Product Change Notice

(PCN Tracking Number: EE-QR-221211-01)

| Renesas Product Type: | RX/RA series with LQFP package products (refer to last page for complete Product list) | | |
| Description of Change: | Addition of back-end factories and corresponding material (please refer to pages 3 - 7 for more details) | | |

10x10mm 64pin LQFP package drawing (Addition)

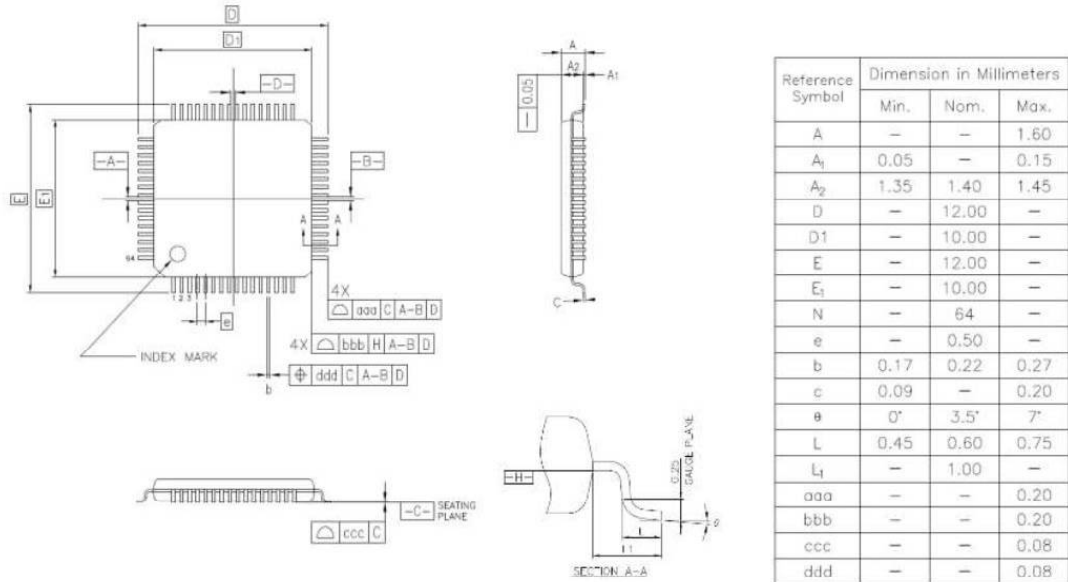
RENESAS Code : PLQP0064KL-A

Dimension comparison: 10x10mm 64pin LQFP package

Greatesk symbol is the same as the JEDEC standard.

10x10mm 64pin LQFP package drawing (Current)

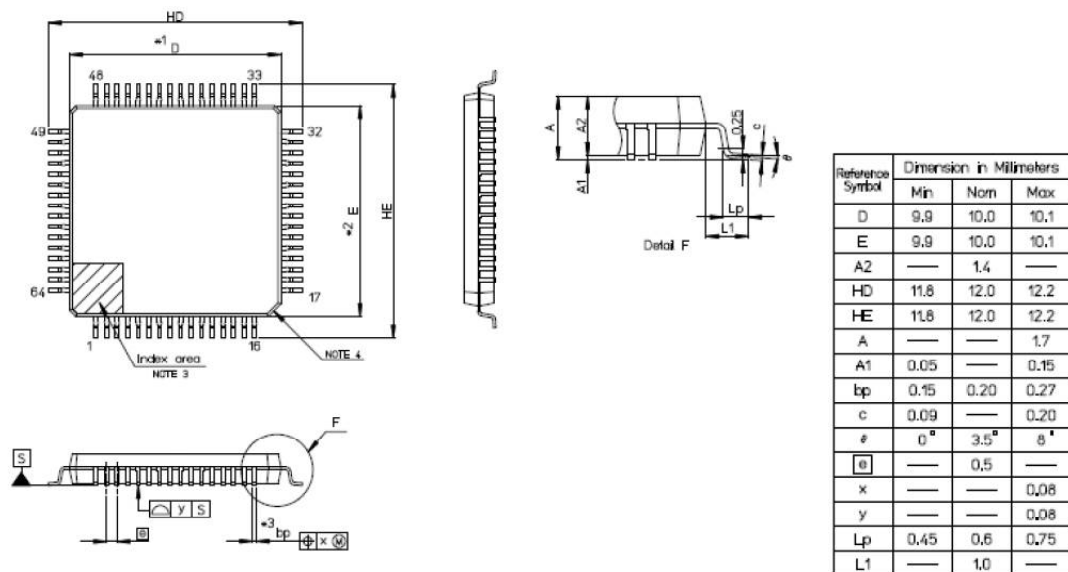
RENESAS Code : PLQP0064KB-C

14x14mm 100pin LQFP package drawing (Addition)

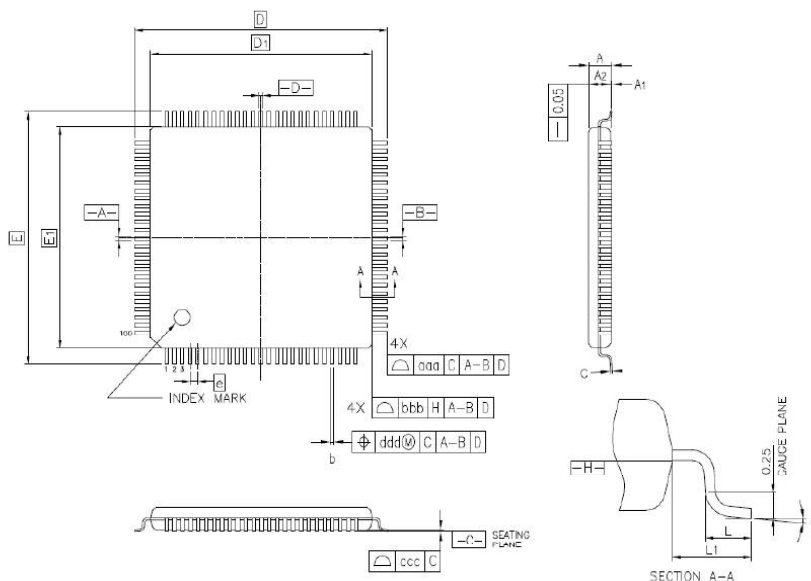
RENESAS Code : PLQP0100KP-A

Dimension comparison: 14x14mm 100pin LQFP package

Greatesk symbol is the same as the JEDEC standard.

14x14mm 100pin LQFP package drawing (Current)

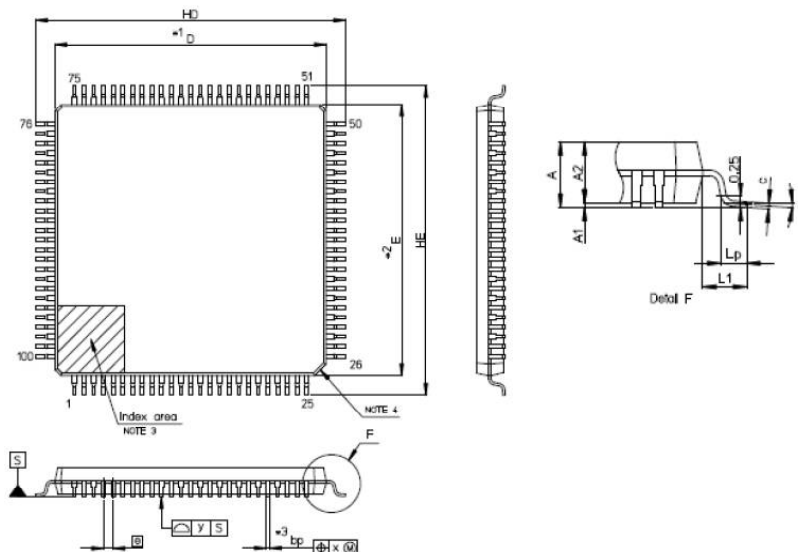
RENESAS Code : PLQP0100KB-B
